0309b. - Stillwater New High School

Title: CMOD 11 - RFI 108 Window Sill Detail

CM Contingency Modification : # 11

RFI #RFI-108: Cast Stone Sill Flashing

S
SILL DETAIL AT BRICK
 8/A303 4/A302

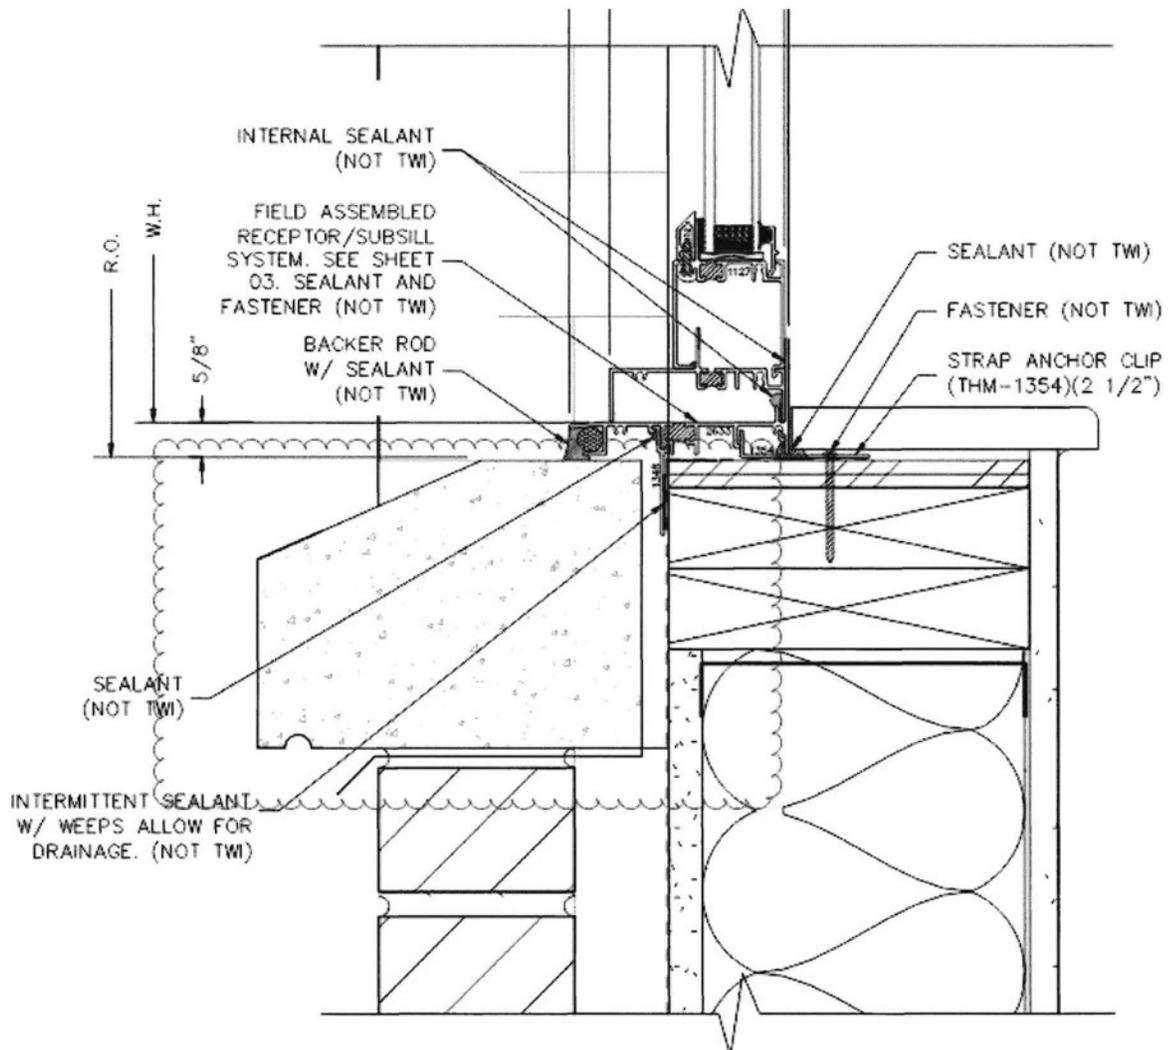
Question **Question from Alexis Perez Willowbrook on Tuesday, Jan 7, 2025 at 10:14 AM CST**
Per the revised thermal window shop drawings, the windows have a metal subsill fin. However, there is no clarification on the flashing for the cast stone. Please advise if installing the sill flashing 1/2" below the metal sub fin with a termination bar is acceptable

It will be acceptable to have the sill flashing 1/2 inch below the metal sub fin with a termination bar. Jeff Thomas, 505 Architects LLC
1/7/2025
